## WARRANTY BULLETIN

Wb00-39

DATE : January 2001	SECTION : 06 - Electrical
EXPIRATION: January 2002	
SUBJECT : REPLACEMENT OF BOSCH ALTERNATOR MODULE

FIGURE 1 : REAR ELECTRICAL COMPARTMENT

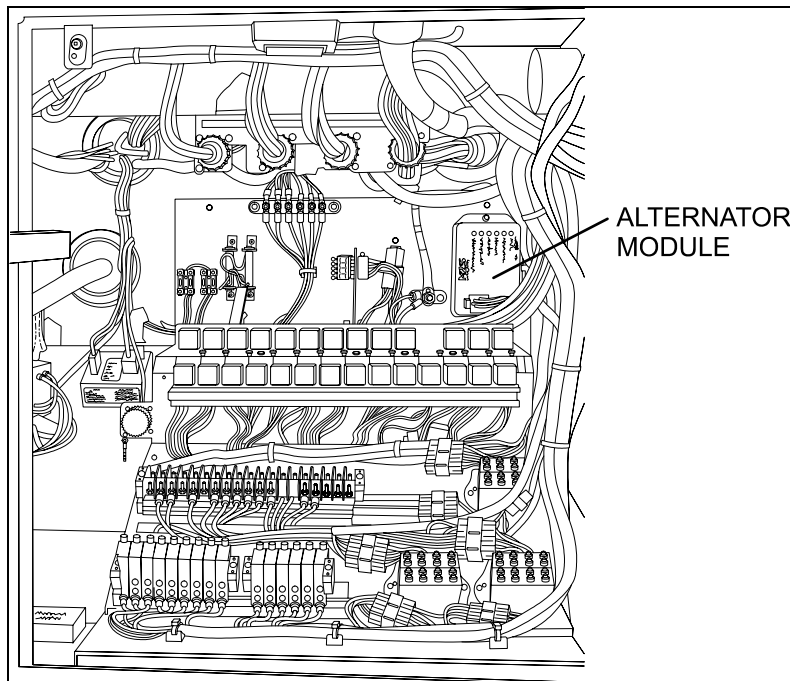
1. Turn ignition switch key to OFF position.
2. Open rear electrical compartment door.
3. Locate Bosch alternator module, refer to figure 1. Check module lot number (lot number is inscribed in bottom R.H. side corner). If lot number is equal to or above 2033A, module is correct. Close the door, the procedure is done. If lot number is below 2033A, replace module using the following steps.

4. Check module selector switch position (ALT. 1 or 2). Make sure new module selector switch is in the same position than previous module.
5. Disconnect harness from previous module. Remove two fixing screws. Install new module using two screws and reconnect harness.
6. Turn ignition switch key to ON position.
7. Inside rear electrical compartment, check that the following alternator module red LEDs illuminate :
  - ETHER START, DRL CANCEL
  - T.T.LT.ALT. #1 or / and #2 as the case may be.
8. Start the engine, check that the alternator module red LEDs extinguish. Check that the following alternator module green LEDs illuminate :
  - HVAC DASH CONTROL
  - ENGINE RUN SIGNAL
9. If everything is normal, procedure is done. If not, you must order another module and start over again.

FIGURE 2 : TOP SECTION OF FRONT SERVICE COMPARTMENT

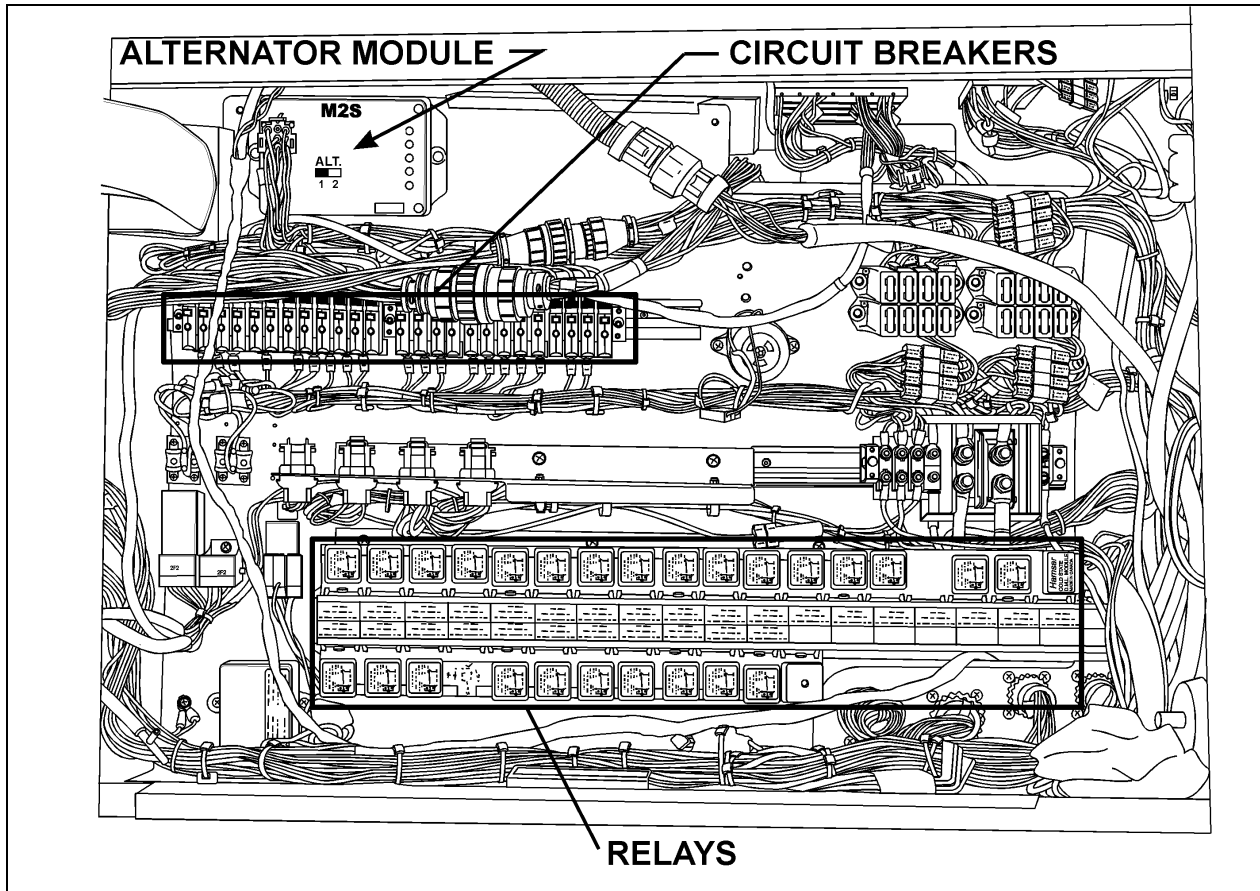
1. Turn ignition switch key to OFF position.
2. Open front service compartment door.
3. Locate Bosch alternator module, refer to figure 2. Check module lot number (lot number is inscribed in bottom R.H. side corner). If lot number is equal to or above 2033A, module is correct. Close the door, the procedure is done. If lot number is below 2033A, replace module using the following steps.

4. Check module selector switch position (ALT. 1 or 2). Make sure new module selector switch is in the same position than previous module.
5. Disconnect harness from previous module. Remove two fixing screws. Install new module using two screws and reconnect harness.
6. Turn ignition switch key to ON position.
7. Front service compartment, check that the following alternator module red LEDs illuminate :
  - ETHER START, DRL CANCEL
  - T.T.LT.ALT. #1 or / and #2 as the case may be.
8. Start the engine, check that the alternator module red LEDs extinguish. Check that the following alternator module green LEDs illuminate :
  - HVAC DASH CONTROL
  - ENGINE RUN SIGNAL.

9. If everything is normal, procedure is done. If not, you must order another module and start over again.
